M25 junction 28 improvement scheme TR010029

5.1 Consultation report: Annexes D, E, F & G

5.1 CONSULTATION REPORT: ANNEXES D, E, F AND G

Regulation Number:	Regulation 5(2)(q)
Planning Inspectorate Scheme Reference:	TR010029
Application Document Reference:	TR010029/APP/5.1
Author:	M25 junction 28 improvement scheme project team, Highways England

Highways England Option

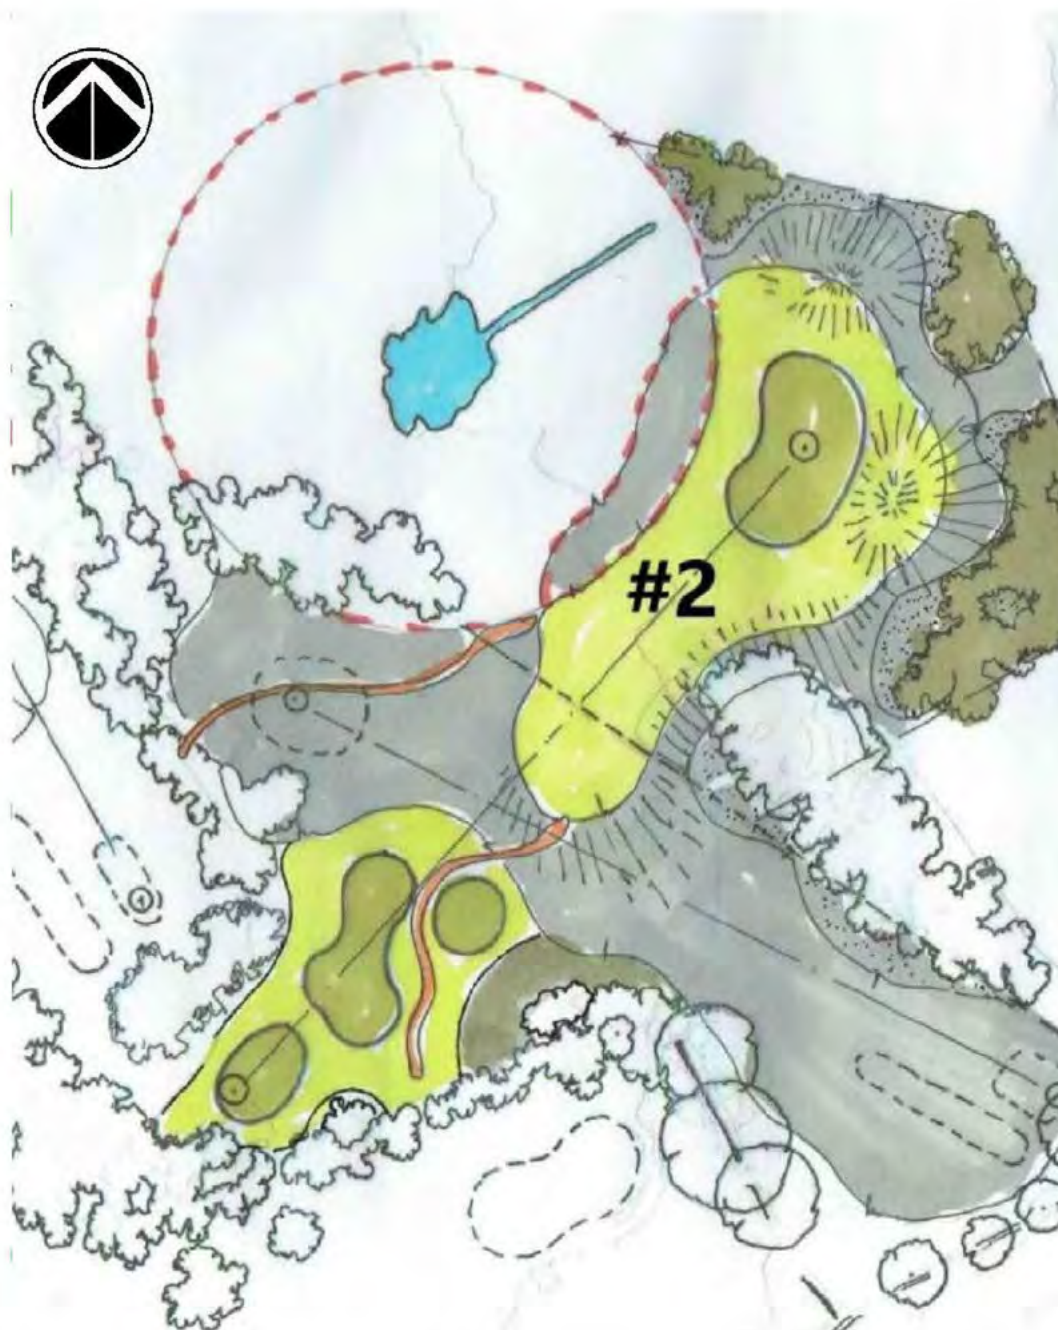
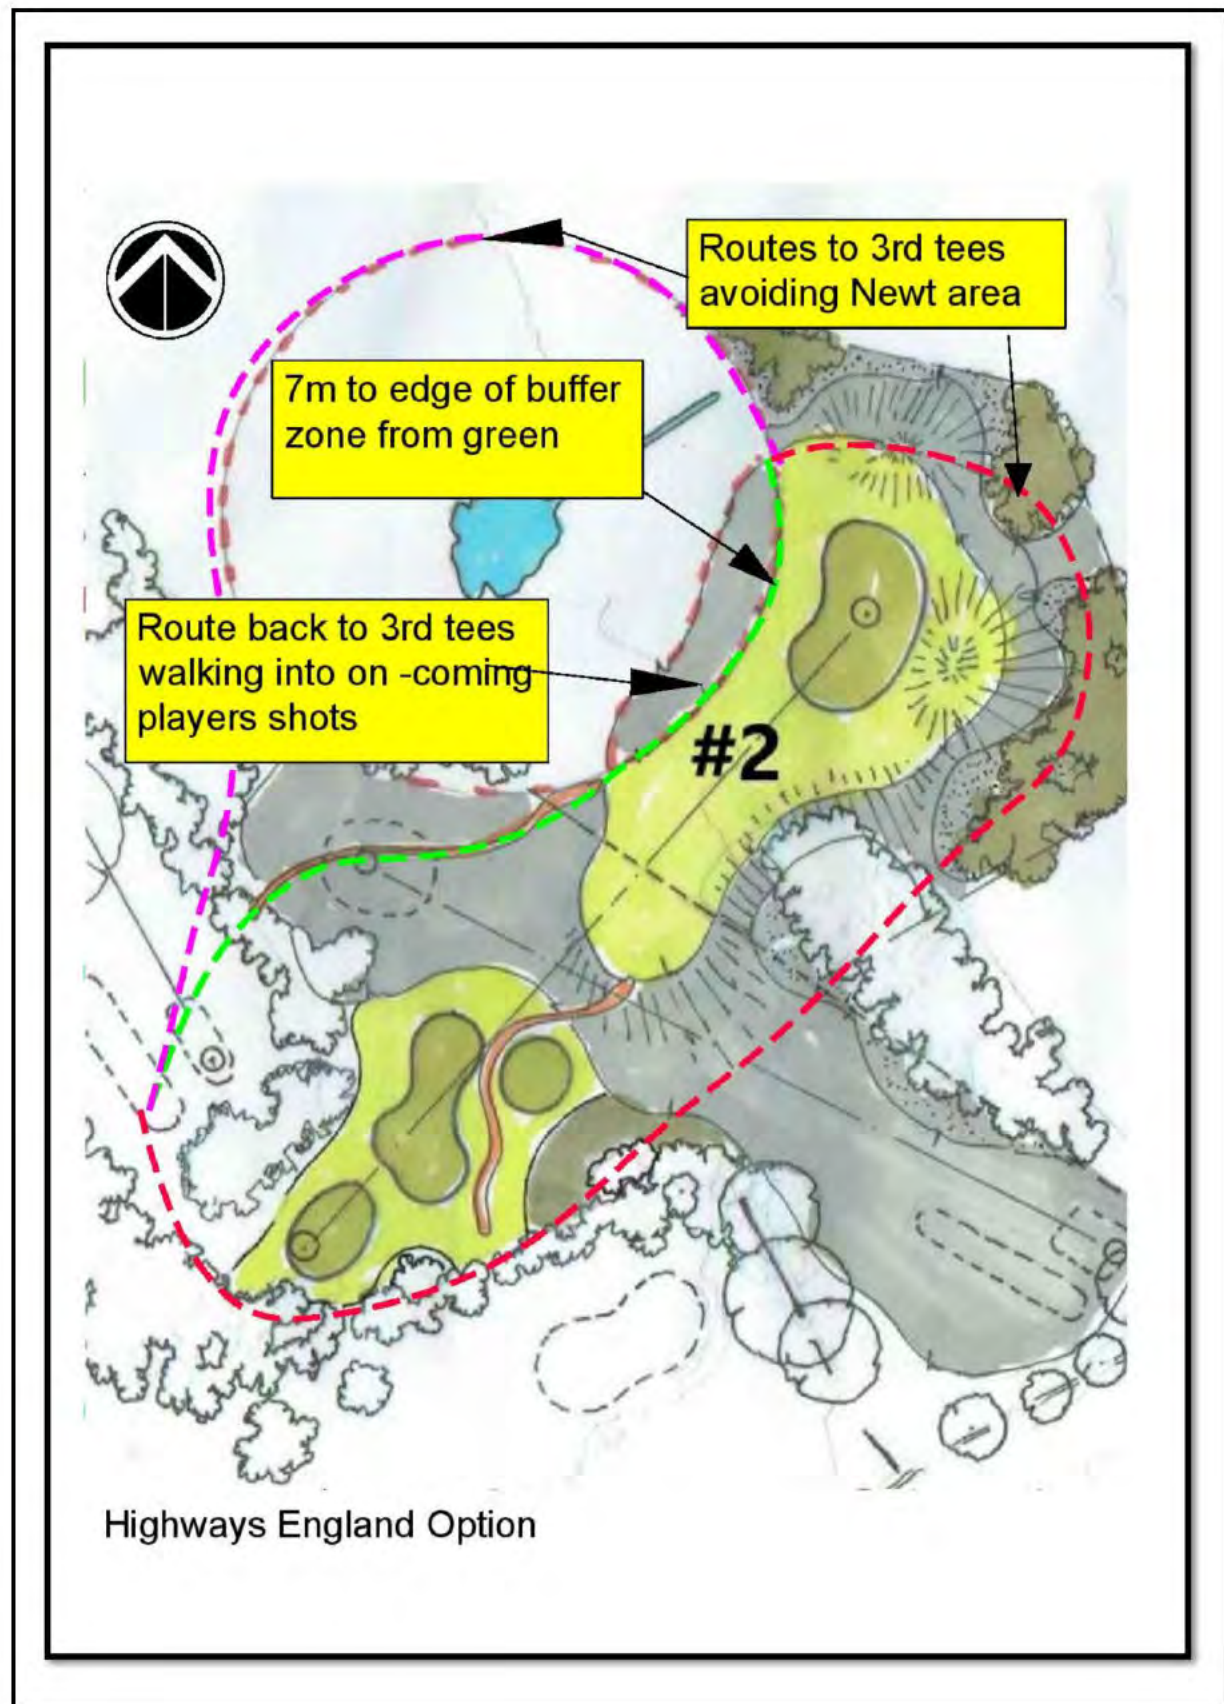
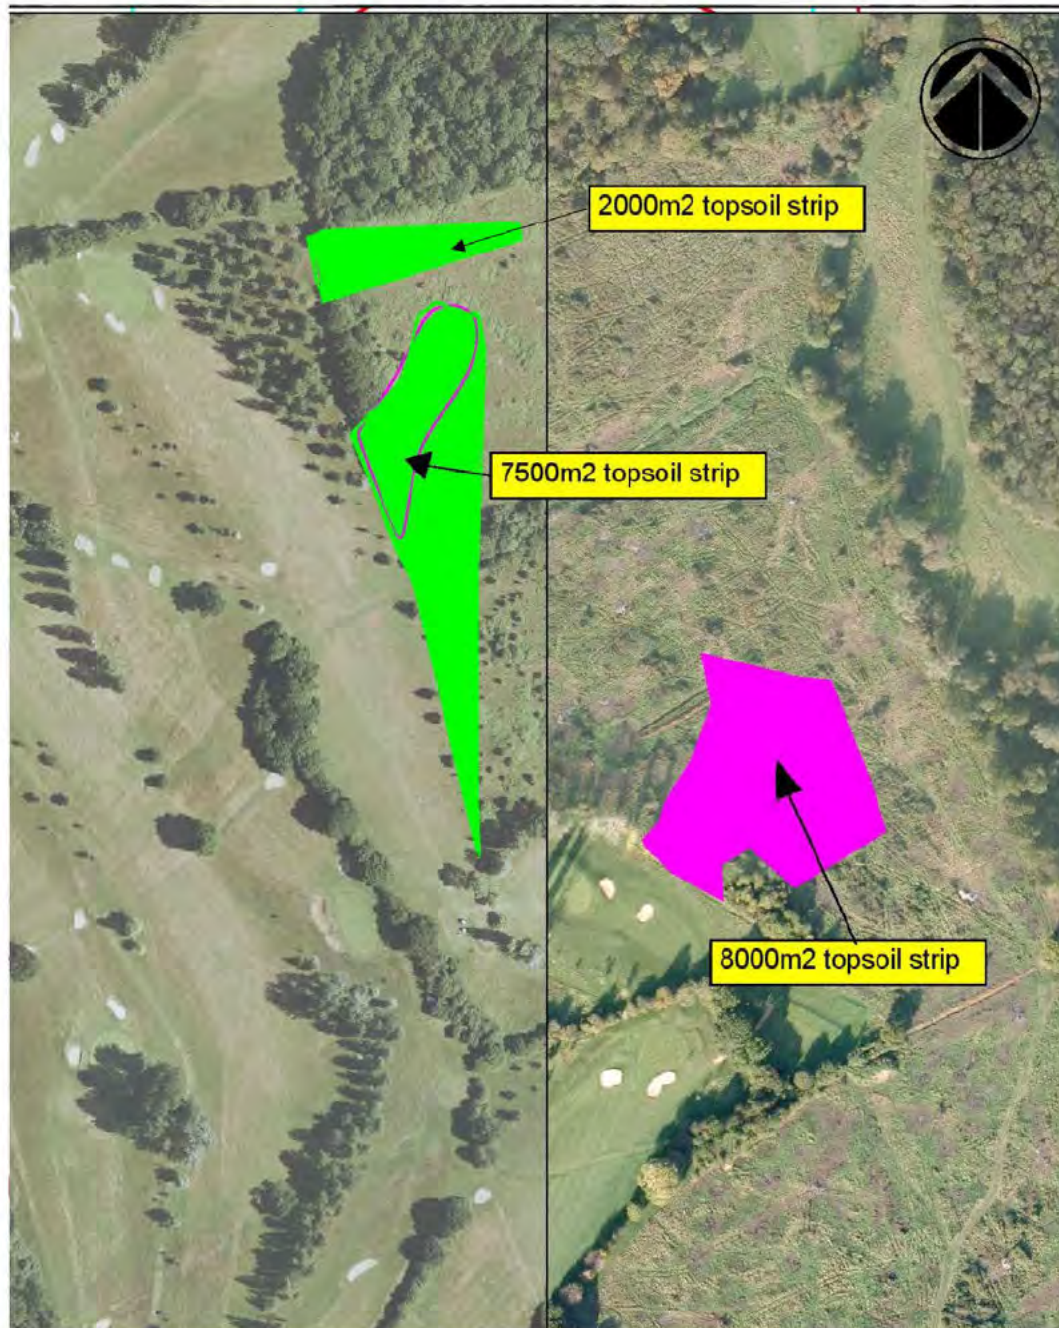
- 2.6.1 While the design presented by Highways England illustrates a reasonable safety distance from the 2nd green to public highway it is still marginal in terms of balls reaching 3rd party land. While the majority will land within the margins illustrated there will still be a percentage that could potentially leave the boundaries of Maylands Golf Club.

- 2.7.1 The design presented by Highways England illustrates an area of circa 8000m² will need to be topsoil stripped to build the hole.
- 2.7.2 While the design previously presented by Weller Designs Ltd (option 1 - 'Do Minimum Addendum') does currently show a requirement to strip a greater extent of land, there is scope to reduce this. By reducing the extent of the mounding to the right of the new 2nd fairway and minimising the stripping in front of the new 3rd tees it is possible to match the extent of stripping required to match that of the Highways England option.

In conclusion we maintain that option 1 of Weller Designs 'Do Minimum Addendum' is the preferable option.

Pink = Extent of strip for Highways England Option
Green = Extent of Strip for Weller Designs Option 1 (amended to reduce extent to east of fairway)
